Highways England
FREEPOST
A428 Black Cat to Caxton Gibbet

A428 Black Cat to Caxton Gibbet Improvements Public consultation – June 2019

CTC Cambridge proposals to improve the scheme for people cycling and other non-motorised road users

CTC Cambridge Proposal 1 A new segregated cycle path alongside the old A428

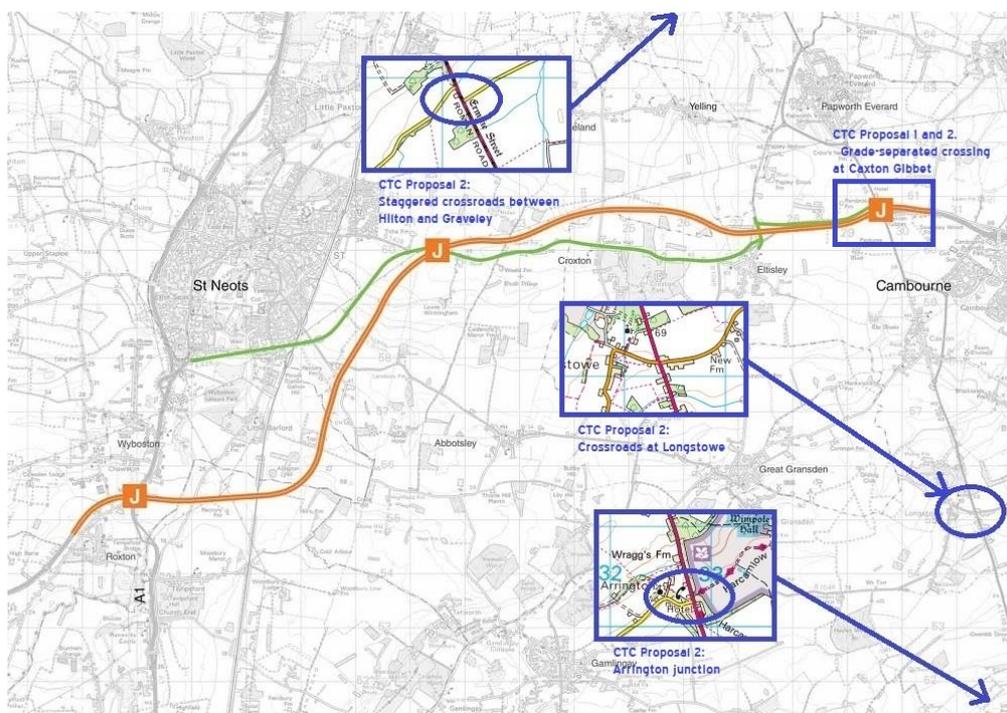
We are disappointed that the Highways England plans do not include a new cycle path connection between St Neots and Cambourne (and hence to Cambridge) despite this being a major discussion item during the early consultation meeting in November 2016 between Highways England and various representatives of cycling, walking and horse-riding organisations.

We think the plans should include the creation of a new segregated cycle path between St Neots and Caxton Gibbet using the route shown in blue on the map above. At Caxton Gibbet the path should be able to connect to a new segregated cycle path between Papworth and Cambourne which we understand is already planned by Cambridge County Council (this new cycle path is also described in CTC Cambridge Proposal 3).

We are aware that cyclists will be banned from using the new A428. We do not object to this, but this prohibition should trigger a requirement for Highways England to provide an alternative route. The old A428 is not an acceptable alternative route for cyclists. Although the old road will carry less motor traffic it will still be too dangerous due to the relatively narrow carriageway and the 60 mph speed limit.

The new cycle path must provide a safe way to cross the A1198 at Caxton Gibbet to complete the connection to Cambourne. This should be a grade-separated crossing (an underpass) which can be included as part of the new

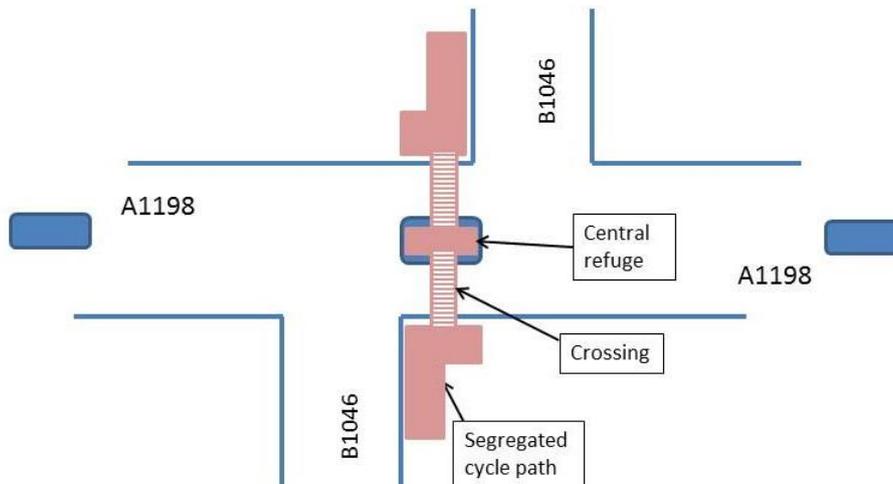
We have identified four main junctions that need mitigation:

1. The crossing of the A1198 at Caxton Gibbet (as identified in CTC Cambridge Proposal 1)
2. The staggered crossroads between Hilton and Graveley
3. The B1046 crossroads at Longstowe.
4. The junction at Arrington (between Croydon/Arrington and the Wimpole Estate)

In all these cases these junctions need to be modified to provide a safer crossing for cyclists to mitigate the effects of the expected high traffic volumes. For the

A typical arrangement - based on the B1046 junction at Longstowe - is illustrated below.

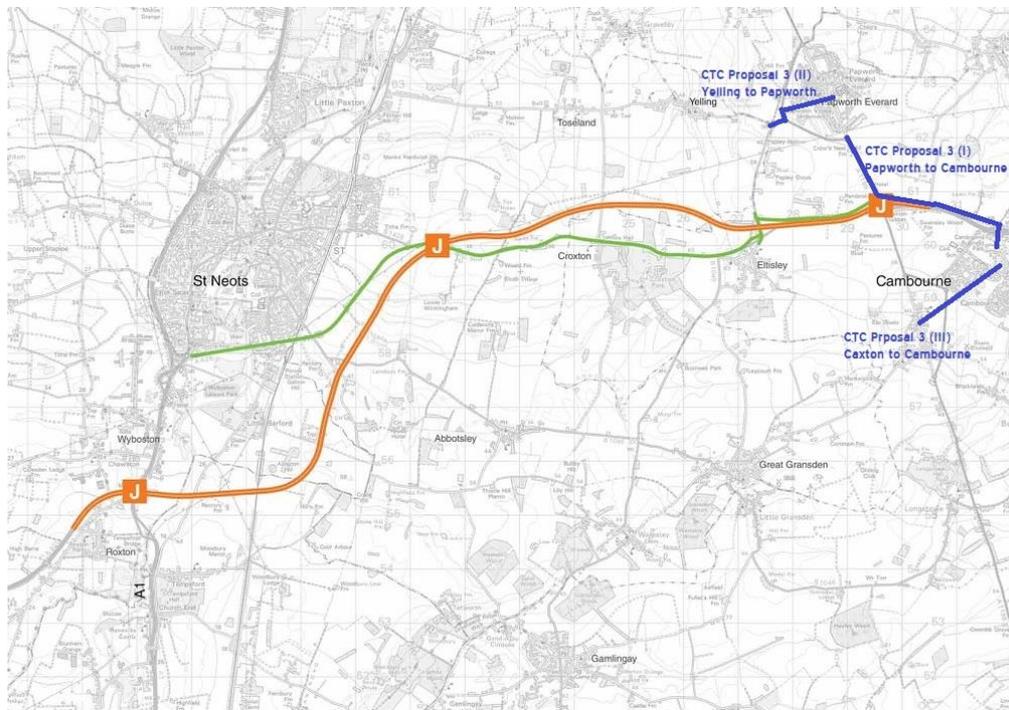
crossing at Caxton Gibbet we recommend a grade-separated crossing (an underpass) which can be constructed as part of the new roundabout and junction. For the other junctions, which require improvements to the existing junctions, we recommend a combination of three elements:

- a two stage crossing of the main road with a central refuge (large enough for all types of cycle)
- a segregated cycle path alongside the A1198 for the staggered junctions
- and a lower speed limit on the A1198 for the section around each junction.

It is essential that the segregated cycle paths and the central refuge provide enough space so that large cycles (e.g. Bakfiets-type bikes) can manoeuvre easily and are fully protected as they wait for a gap in the traffic. The segregated cycle paths should also extend down the side roads so that cyclists can cross the minor road well away from the junction.

Connecting Caxton village and Cambourne

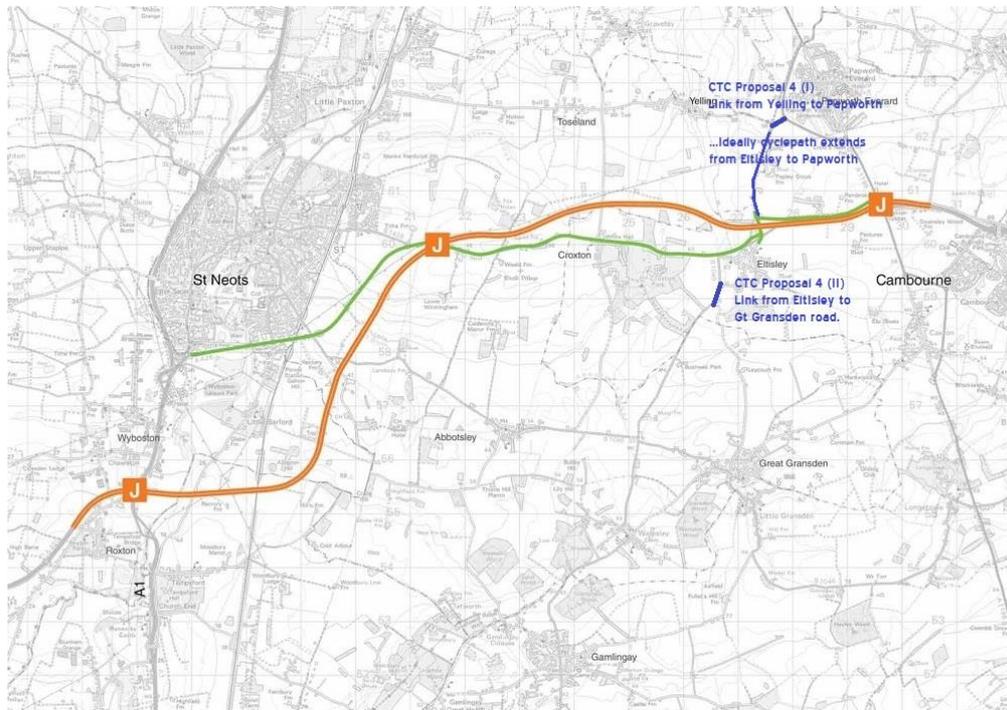
Our third proposal is to surface the existing bridleway between Caxton village and Cambourne with an all-weather surface to provide a good quality direct cycle route between the two villages. The existing bridleway is rough and muddy in places and the only alternative route involves cycling along a section of the A1198.

If the bridleway cannot be improved, a less-preferred alternative is to make it possible to ride between these two villages using existing roads. This would require a segregated cycle path alongside the section of A1198 between the roundabout north of Caxton village and the roundabout west of Cambourne.

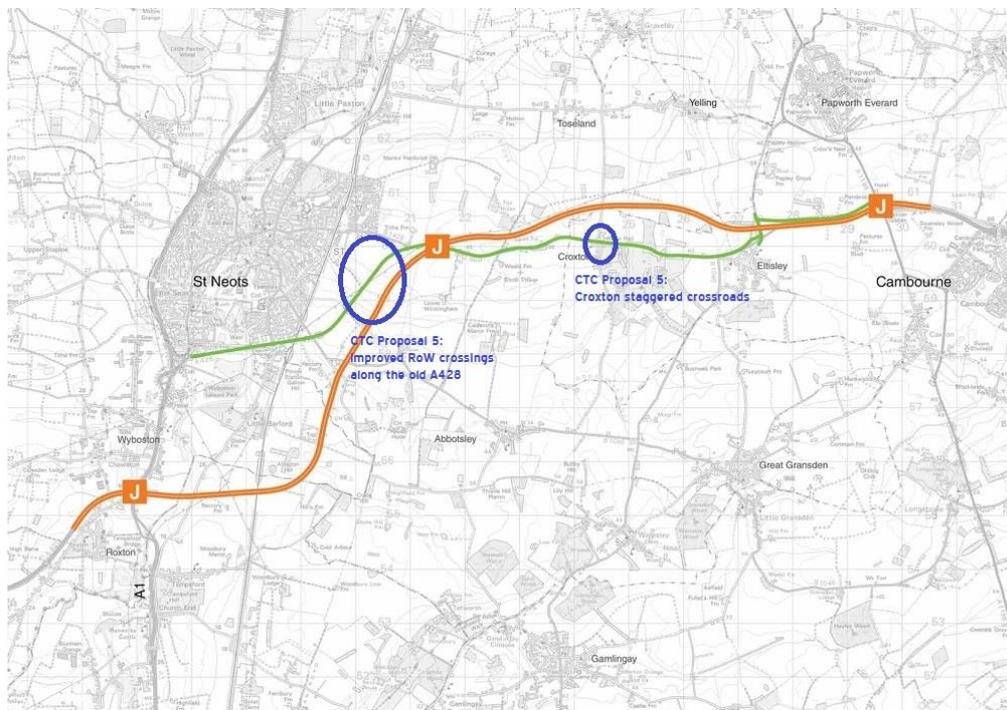
We think segregated cycle paths are needed on two sections of the B1040:

1. the 300m section of B1040 from the turn for Yelling to the roundabout where it meets the A1198. We mentioned this above.
2. the 300m section of B1040 from the turn for Eltisley village as far as the turn Great Gransden. This provides a link between Great Gransden and Eltisley and on to the A428 cycle path proposed in CTC Cambridge Proposal 1

Ideally we would like to see a cycle path alongside the B1040 all the way from Papworth Everard to Eltisley. This would complement our earlier proposals by providing a complete connection between Eltisley and Papworth. We think a segregated cycle path is needed for the whole of this section because this section of the B1040 will likely see the largest increase in traffic volume.
